ASTP
FLIGHT READINESS REVIEW BOARD

VOL. II SPACECRAFT-ROCKWELL

APOLLO-SOYUZ TEST PROJECT
CSM 111/DM-2/DS 5/SLA 18
FLIGHT READINESS REVIEW
PREBOARD REPORT
JSC

4 JUNE 1975

B+ LEAD INSTALLATION

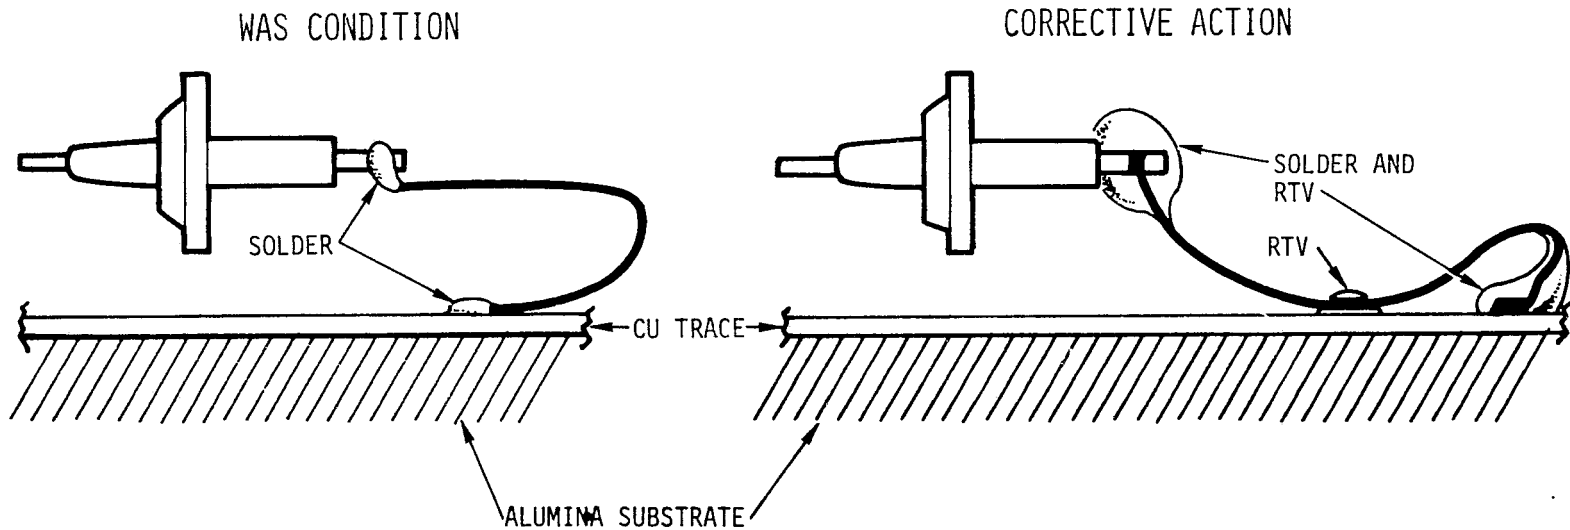
ATS-6 POWER AMPLIFIER VIBRATION TEST FAILURE

- POT FINAL AMPLIFIER B+ TERMINATIONS WITH RTV & RTV LEAD CENTER TO SUBSTRATE BASE

LOOSE COMPONENTS

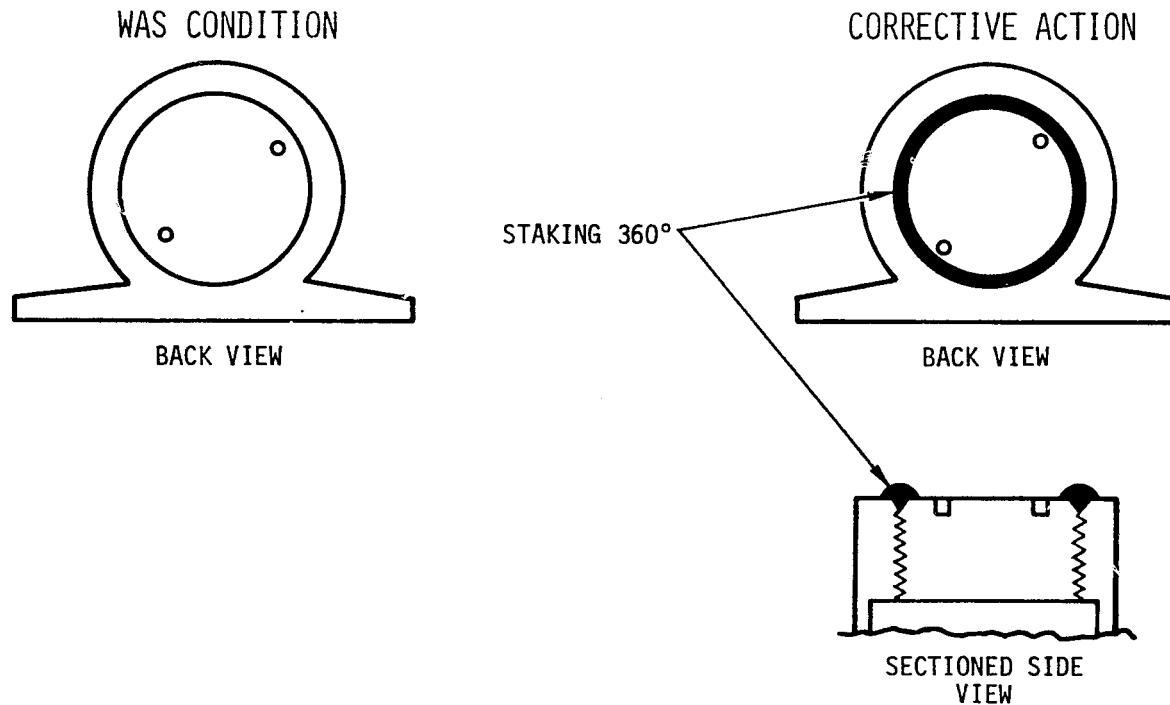
ATS-6 POWER AMPLIFIER VIBRATION TEST FAILURE

- RE-REVIEW POWER AMP SOLDER JOINTS & COMPONENTS FOR VIBRATION SENSITIVITY
- STAKE BOTH RF TERMINAL LOAD INSERTS

RESISTOR TERMINATION BLOCK

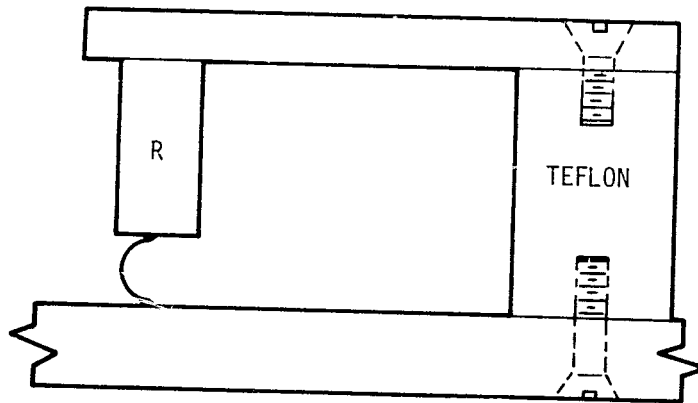
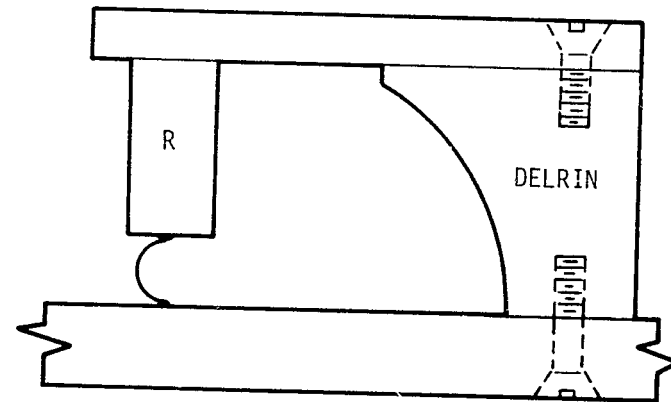
ATS-6 POWER AMPLIFIER VIBRATION TEST FAILURES

- USE DELRIN WITH IMPROVED CROSS SECTION
- DIMENSIONALLY CONTROL HELICOIL INSERT
- STAKE MOUNTING SCREWS
- VERIFY BY OFF-LIMIT VIBRATION TESTING

FIRST THERMAL VACUUM ANOMALY

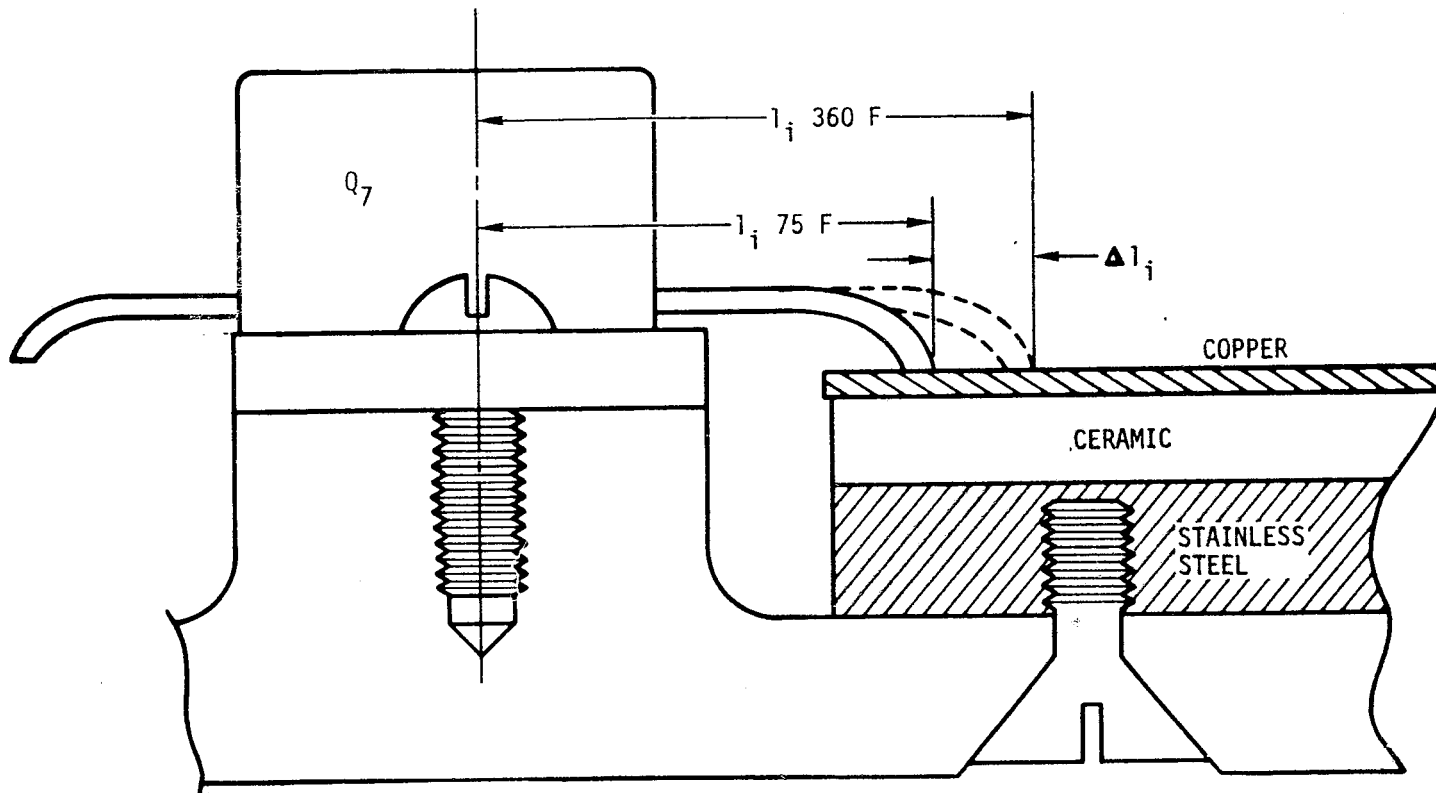
- RF POWER DROPPED 2.2 dB

- TEARDOWN INSPECTION REVEALED BROKEN SOLDER CONNECTION AT ONE BASIC AMPLIFIER MODULE (OUTPUT HYBRID)
- SOLDER JOINT 20 POWER INSPECTION REVEALED SEVERAL CRACKED JOINTS
- FLIGHT UNITS 20 POWER INSPECTED AND CRACKED JOINTS IDENTIFIED
- SOLDER JOINT STRESS ANALYSIS REVEALED MARGINAL JOINT CONFIGURATION WITH SAFETY FACTOR <1.0

- DEFINED NEW LOW STRESS SOLDERING PROCESS
- VERIFIED BY COMPARISON TESTING OF OLD AND NEW PROCEDURES
- POWER SUPPLY JOINTS FOUND ADEQUATE
- REVIEWED ALL SOLDER JOINTS
 - DESIGN ACCEPTABLE (LOW LEVEL AMPLIFIER & POWER SUPPLY)
 - RESOLDER (BASIC & INTERMEDIATE AMPLIFIER)

ATS POWER SUPPLY
Q₆ SHORT

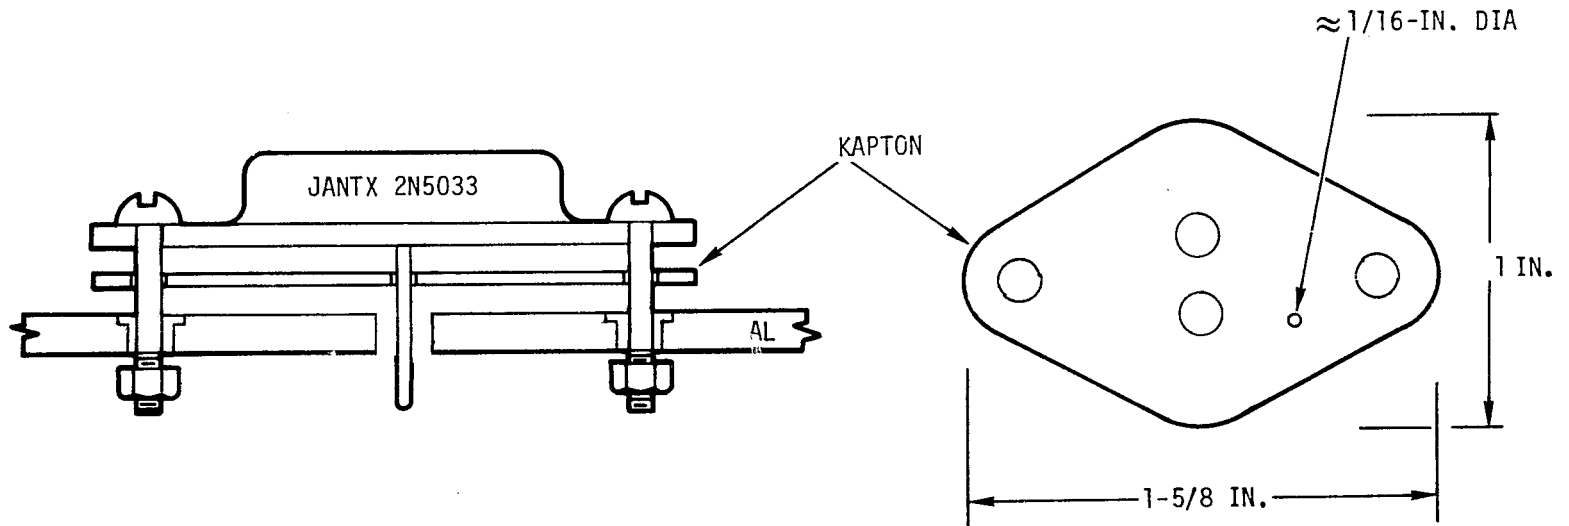
- POWER AMPLIFIER INPUT CURRENT INCREASED TO 15 AMPS; VOLTAGE, CURRENT AND INTERNAL TEMPERATURE DATA DISPLAYS WERE NOISY
- TROUBLESHOOTING REVEALED THAT THE POWER AMPLIFIER 28 VDC INPUT PIN WAS 0.687 OHMS TO CHASSIS GROUND RATHER THAN 1 MEGOHM MIN

- FAULT IN THE POWER SUPPLY - THE POWER SWITCHING TRANSISTOR Q₆ COLLECTOR (CASE) WAS FOUND SHORTED TO CHASSIS WITH A CHARRED HOLE IN THE KAPTON 2 MIL INSULATOR AND ARC PITTING ON BOTH TRANSISTOR AND MOUNTING BRACKET SURFACES

- KAPTON SHORT CAUSED BY ARCING POTENTIAL DUE TO CHARGE POTENTIAL ON INPUT POWER LINES ACROSS HOLE IN KAPTON
- ARCING UNIQUE TO QUAL TEST SETUP
- CSM INSTALLATION GROUNDED - THEREFORE SATISFACTORY

FRRID 111.2.8.2 (CONT)
MAIN BUS A AND B CURRENT GLITCHES

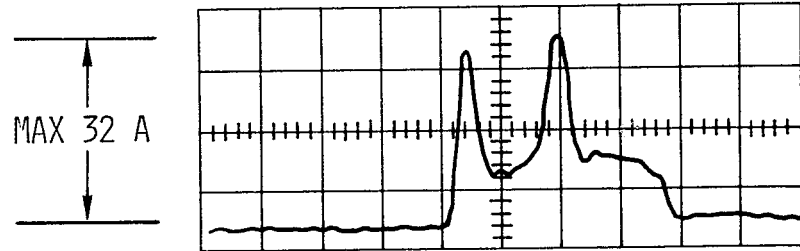
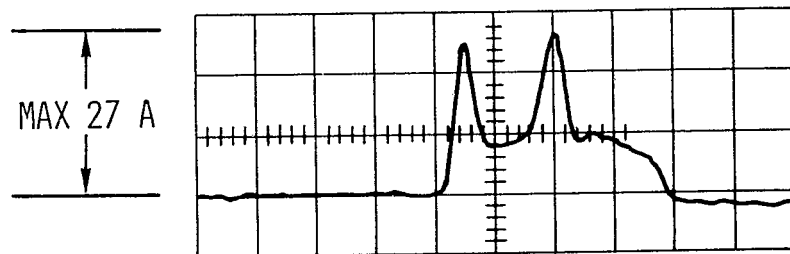
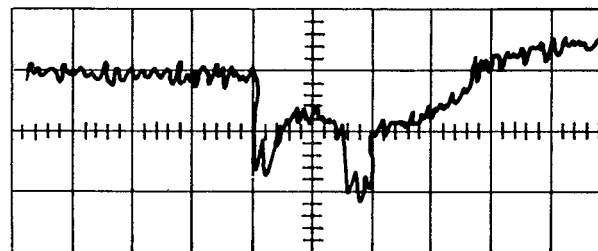
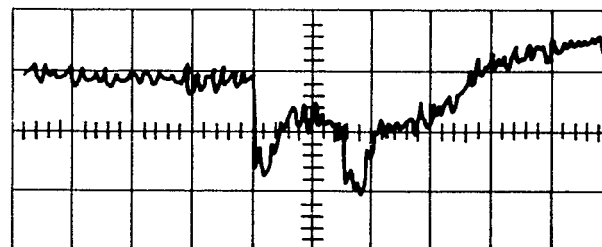
- UNABLE TO DETERMINE EXACT CAUSE OF CURRENT GLITCH
- MOST PROBABLE CAUSE IS FAILURE OF FILTER CAPACITOR IN ONE OF LOADS PREVIOUSLY IDENTIFIED
 - MOST LIKELY UNIT IS ATS-6 PA, SINCE GLITCH IN RECEIVER SIGNAL STRENGTH WAS NOTED AT SAME TIME AS CURRENT GLITCH
 - ANALYSIS OF PA SHOWED THAT MOST LIKELY FAILURE WAS FILTER CAPACITOR IN PA POWER SUPPLY
 - POWER SUPPLY CAPACITOR INSPECTION AND DISSECTION DID NOT SHOW EVIDENCE OF SHORT
 - IF PROBLEM WOULD OCCUR IN FLIGHT, SWITCH TO REDUNDANT PA
